**Submission of Layout Plan and Application for Commercial Development on IL No.8945 Causeway Bay, Hong Kong  
under s16 of the Town Planning Ordinance (Cap.131)**

**s.16 Planning Application No. A/H7/185 - Departmental Comments**

**Response to Comments**

April 2024

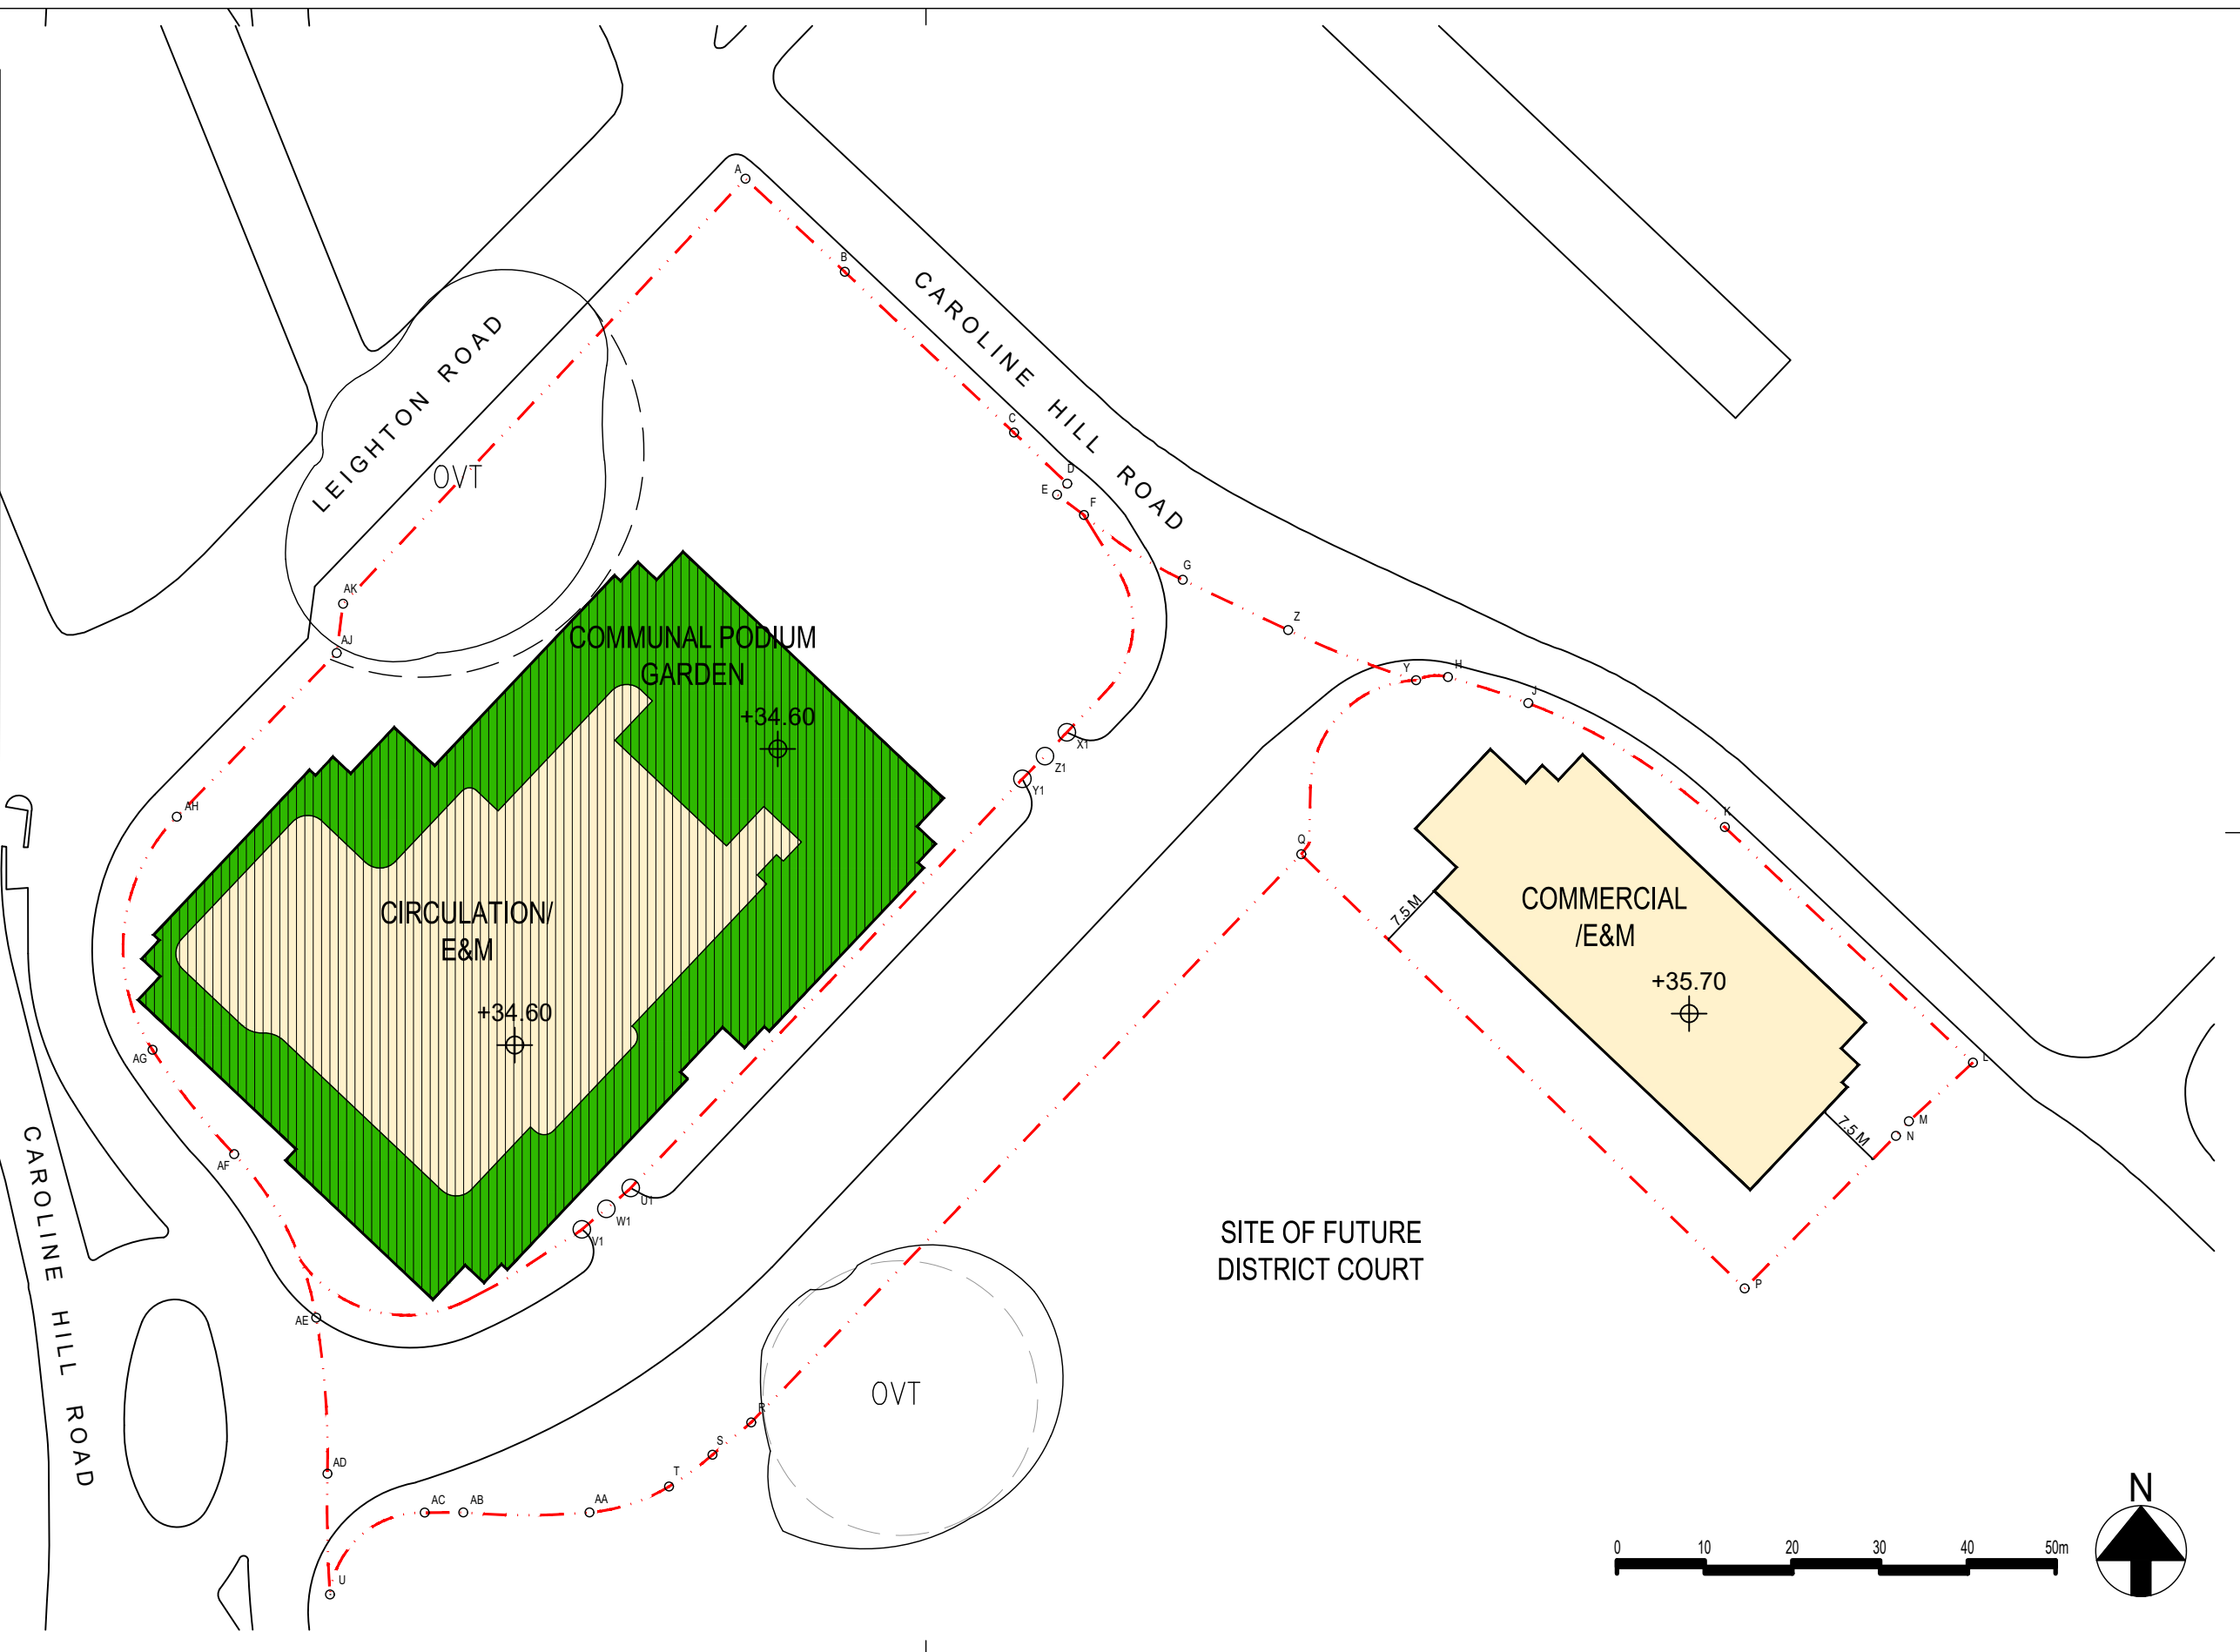
<p><b>4. PLANNING DEPARTMENT</b>                  (Received via email from Mr. David LEUNG, TP/HK10 HKDPO on 3 April 2024)</p>		
<p><b>Comments</b></p>		<p><b>Responses</b></p>
<p>Please note the following comment in respect of the AVA submitted:</p>		
	<ul style="list-style-type: none"> <li>In relation to Tower 3 (T3), it is noted that the floor layout of its 2/F in the AVA report is <b>inconsistent</b> with the floor layout plan of 2/F of T3 as shown in <b>MLP-008</b> of the planning statement and that as shown in <b>Figure 4.8b</b> of the planning statement. Please clarify any impact on the AVA conclusions.</li> </ul>	<p>The elevated design on 2/F of T3 is modelled as approx. 18m(W) x 10m(H) in the AVA-IS. As the design continue to develop, the lift lobby on 2/F of T3 is enlarged to allow more room for pedestrian flow. The amendment results in an extension of lift lobby towards the elevated void with approx. 5m (W) x 5m (H). Refer to illustration provided in response for next comment below.</p> <p>The overall ventilation performance along the Site Boundary and Assessment Area due to the amendment would be minimal with confined difference near the amended lift lobby due to the following reasons:</p> <p>Podium level incoming wind would reach T3 from the eastern side along Caroline Hill Road and from the south-western side under both annual and summer conditions.</p> <p>For incoming wind from eastern side, the amended lift lobby is a minor extension from core structure and away from the north-eastern site boundary, which minimize the blockage. The elevated design with at least. 16m (W) x 10m (H) are free of obstruction for eastern wind. With additional 5m(W) x 5m (H) void atop the lift lobby, the effectiveness of the void would be insignificantly affected. Wind from eastern side would still be able to flow through underneath the tower and the influence on Caroline Hill Road would be minimal.</p>

<p>For incoming wind from south-western direction, the elongated shape of core structure would dominate the wind environment and cast a localized wind shadow at the elevated area under T3. The amended lift lobby would fall within shadow zone and the influence from the amendment on ventilation performance would be insignificant.</p> <p>In summary, the amendment would impose insignificant ventilation impact to wind performance along the site boundary and assessment area, the AVA conclusions remained valid.</p>
	<ul style="list-style-type: none"> <li>As the elevated design on 2/F of T3 is one of the enhancement measures and if the floor layout of 2/F of T3 in <b>MLP-008</b> and <b>Figure 4.8b</b> of the planning statement is selected and confirmed, please specify the dimension (including width calculated from site boundary and the height measured from +18.2mPD) of the <b>narrowest part</b> of the elevated void on 2/F of T3.</li> </ul>	<p>The elevated design varies from approx. 21m widest to 16m narrowest with a height maintained with approx. 10m. An additional void with approx. 5m (W) x 5m (H) is located above the amended lift lobby.</p>
